# Supplement to Final Environmental Impact Statement for Proposed Issuance of a New Source National Pollutant Discharge Elimination System Permit to Estech, Inc.'s Duette Mine Manatee County, Florida

EPA 904/9-82-104
December, 1982

# Environmental Impact Statement Supplement

# Estech, Inc.
# Duette Mine
# Manatee County, Florida

FIGURE 2-1

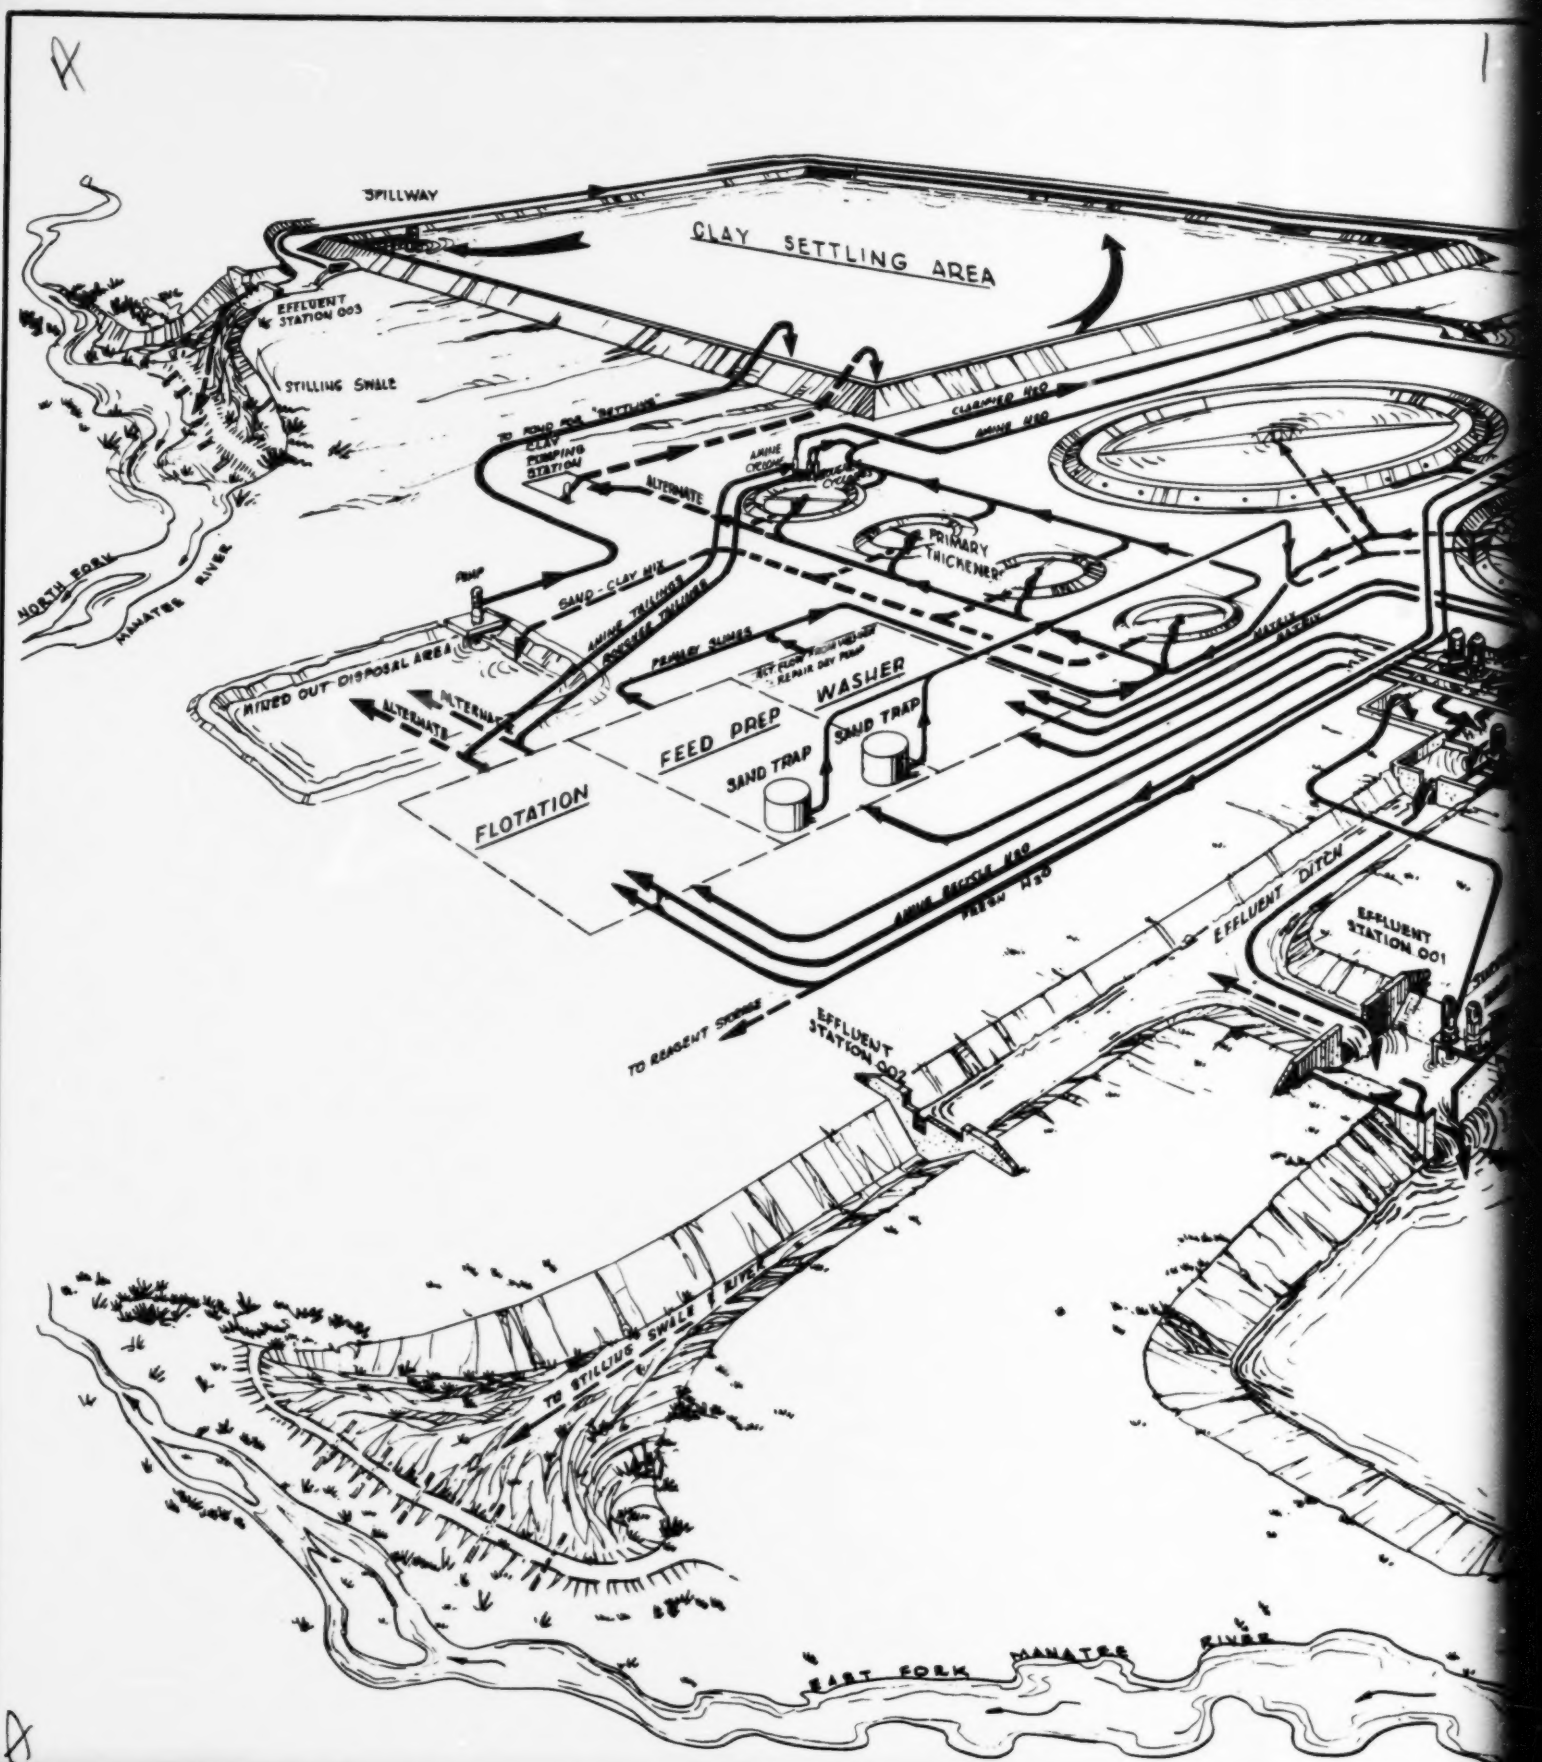
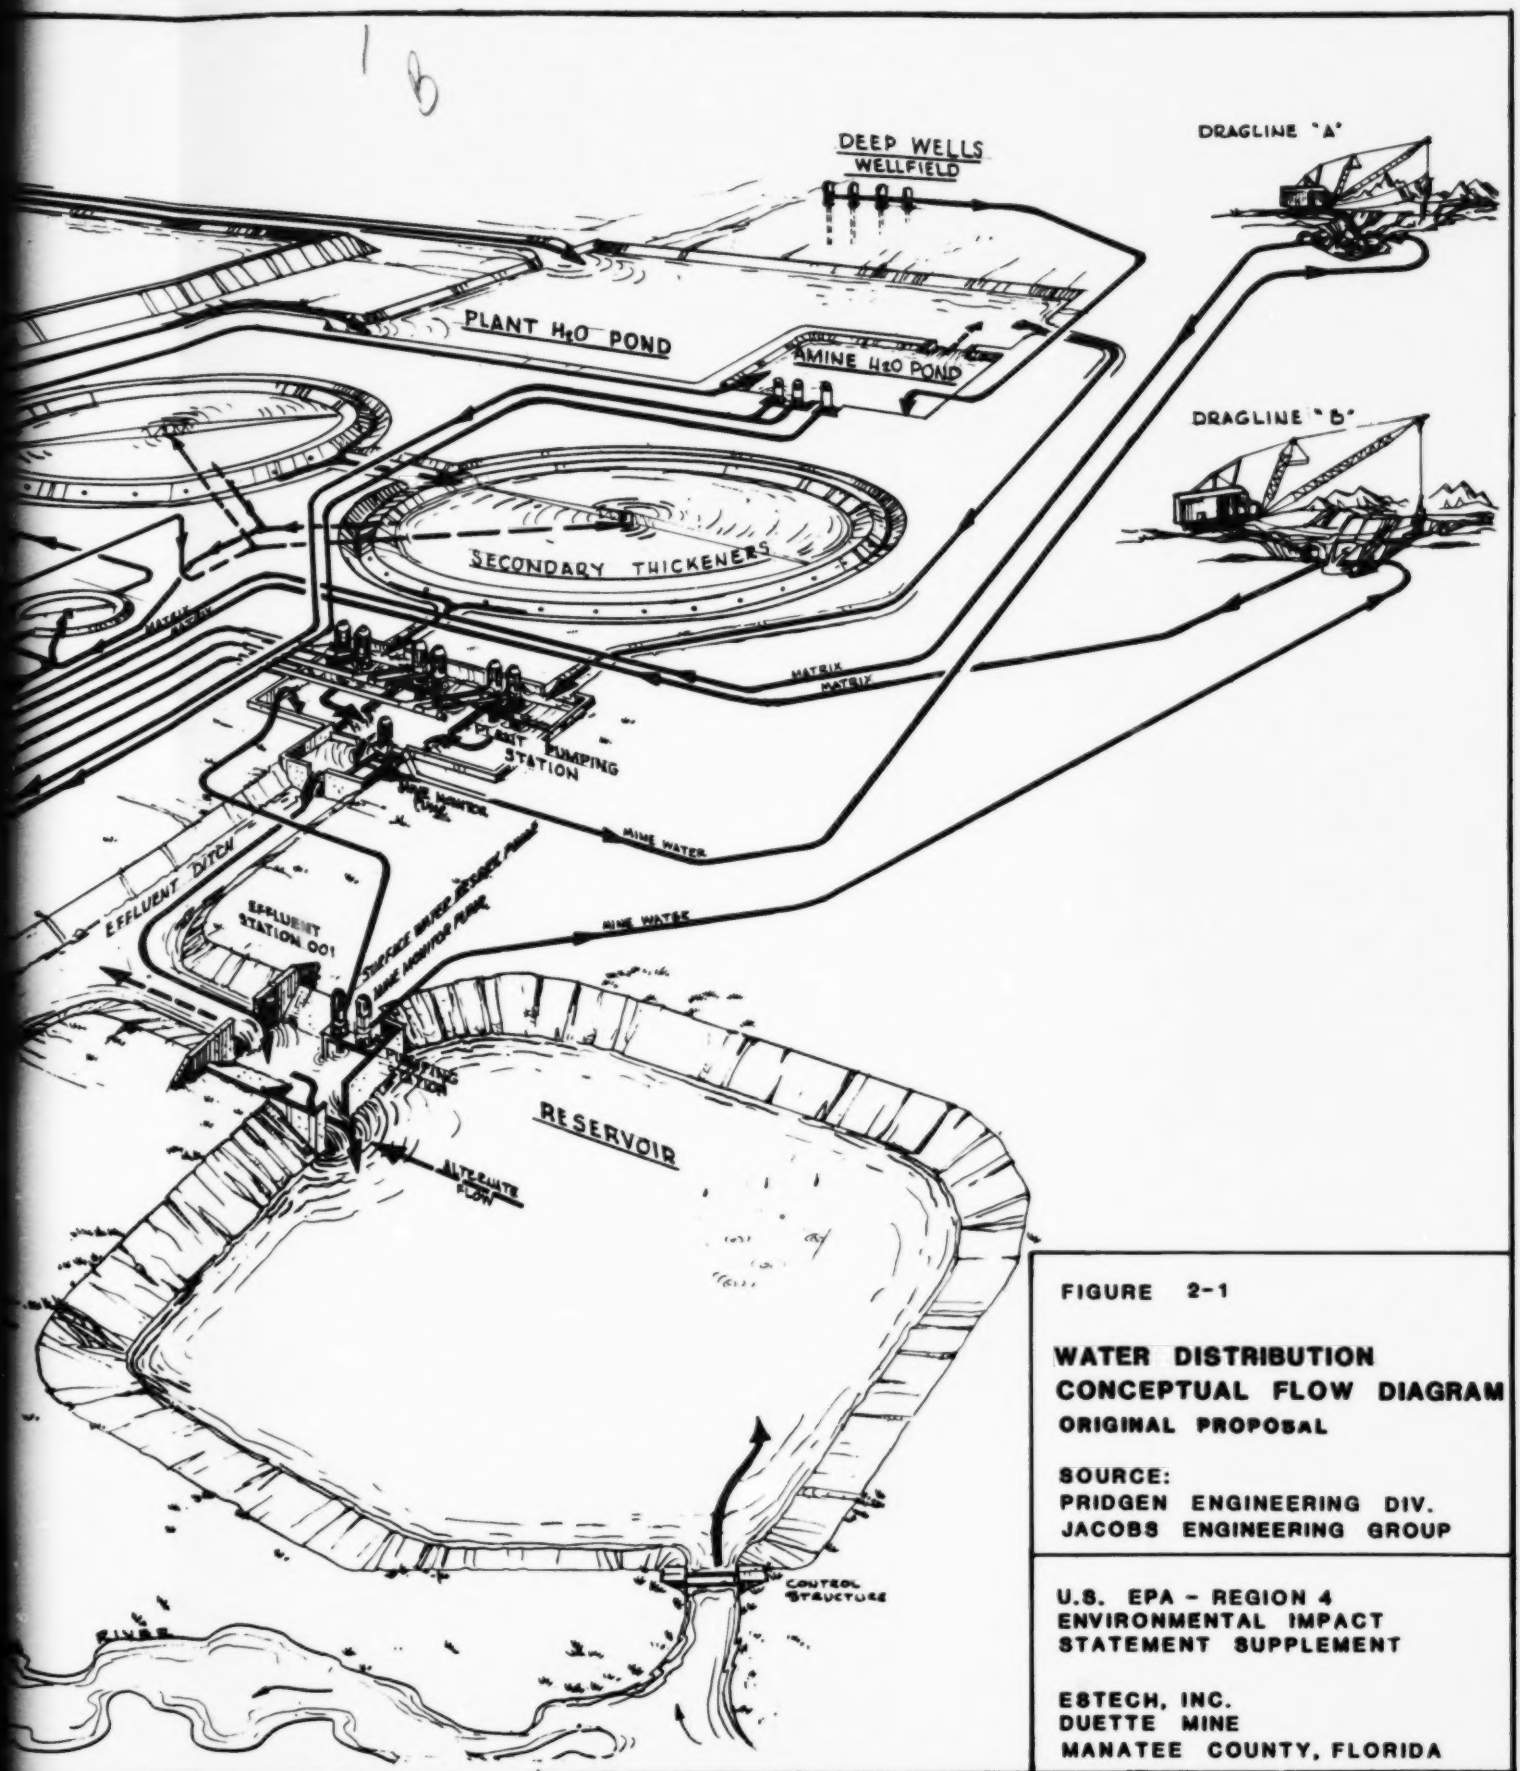
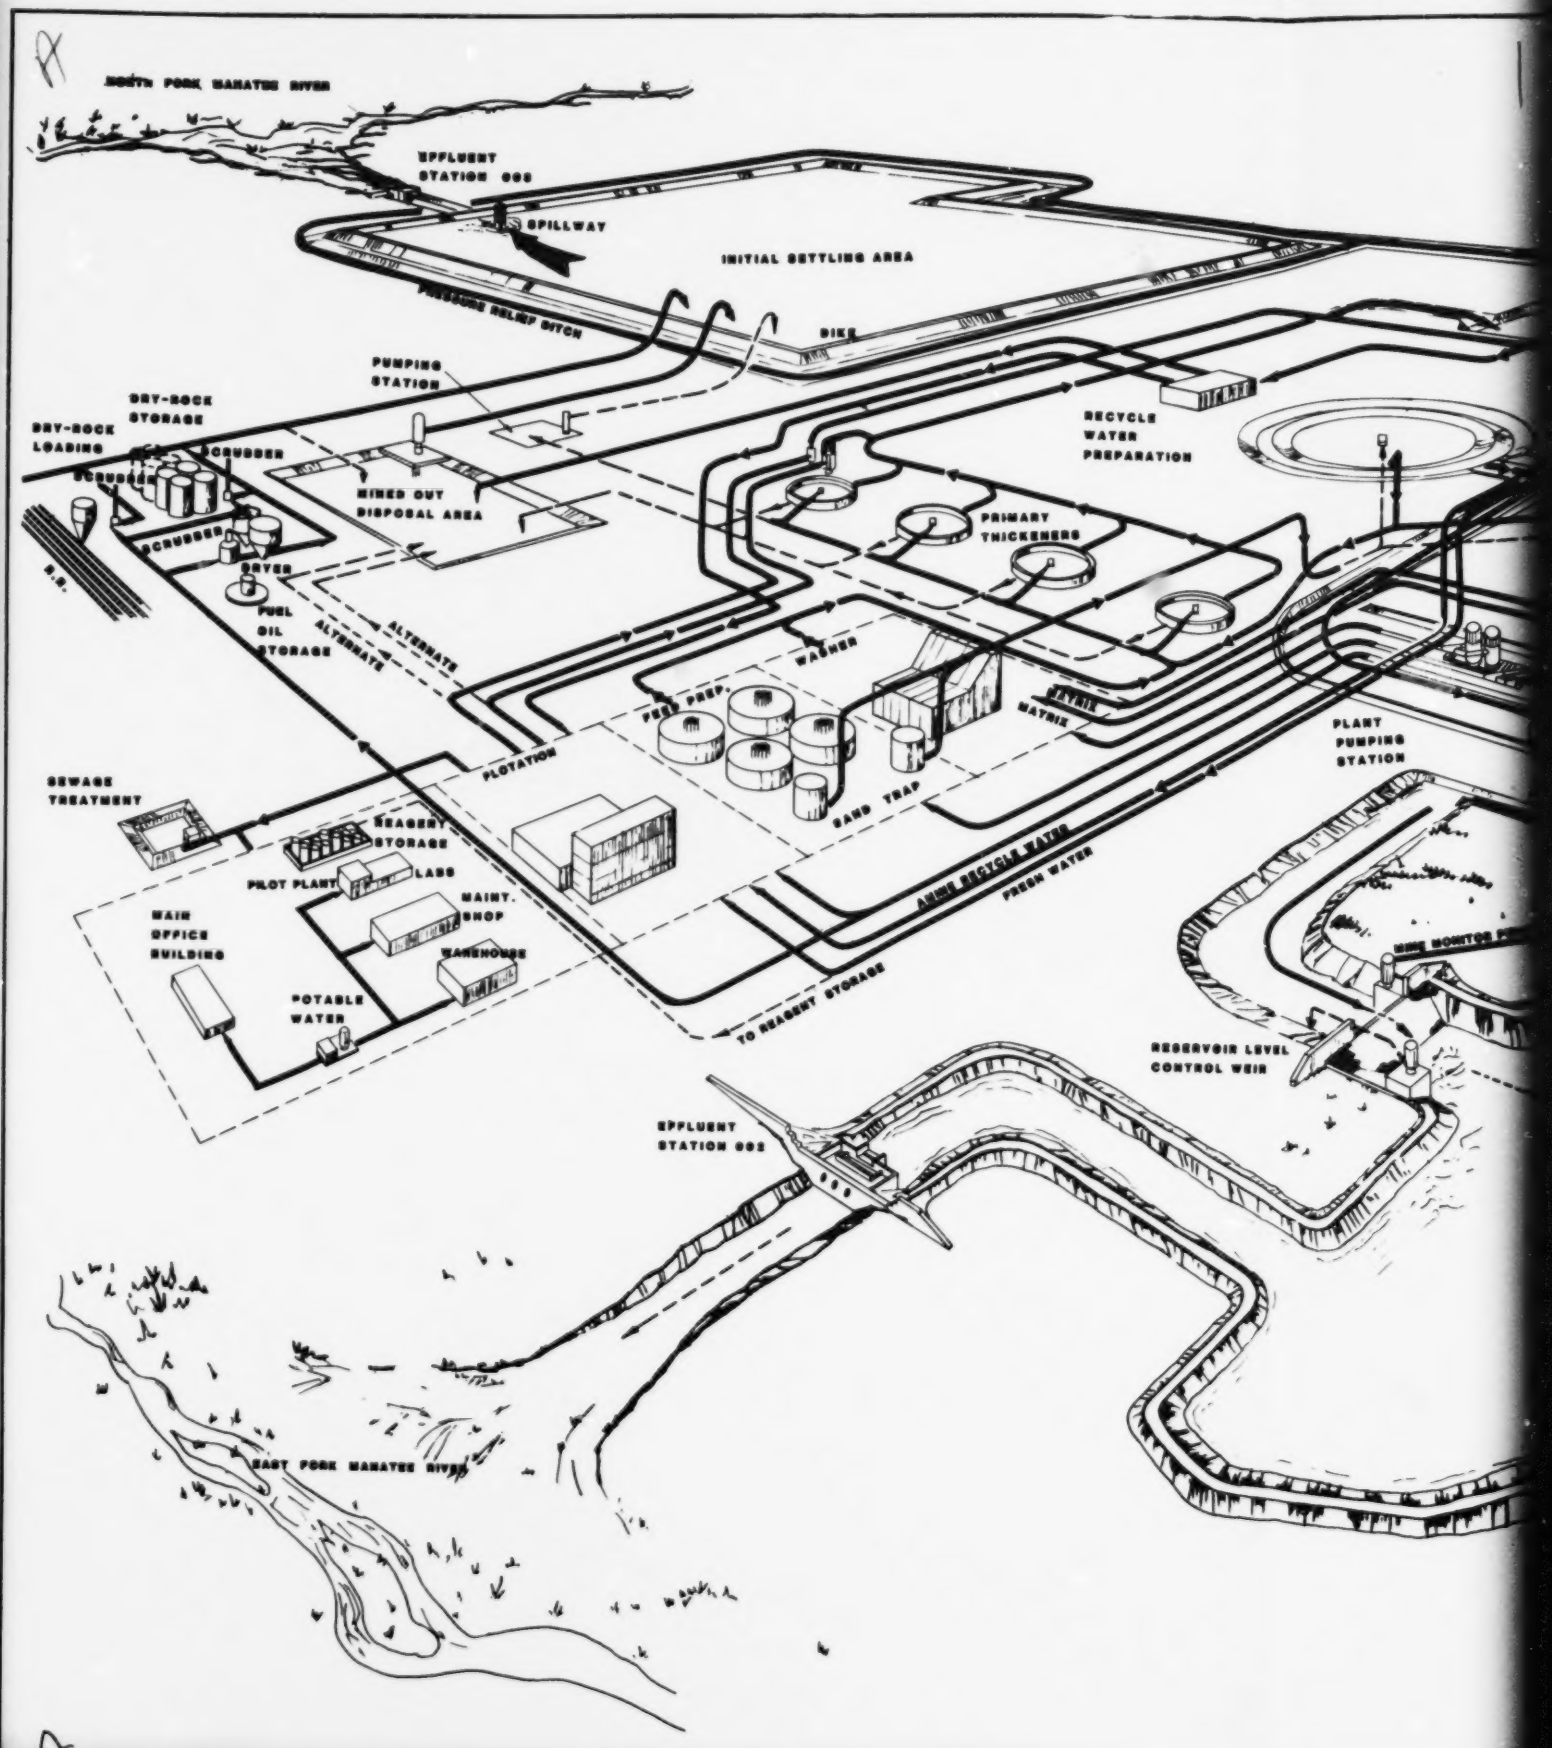
Elimination of Surface Water Intake - As originally proposed, Estech would have constructed a stationary weir designed to direct excess flow from the East Fork of the Manatee River under high flow conditions into an on-site reservoir (Figure 2-1). Under the current plan, there would be no diversion and impoundment of waters of the United States (Figure 2-2).

around the reservoir for additional water storage capacity. These changes eliminate the capability to divert water from the East Fork Manatee River and result in two discharge points (001 and 002) being in direct flow alignment with each other. Discharge point 001, being upstream of 002, becomes redundant and is therefore proposed to be eliminated. Discharge point 002 would be positioned to control discharges (if any) at the downstream end of the reservoir. No change in discharge point 003 is proposed.
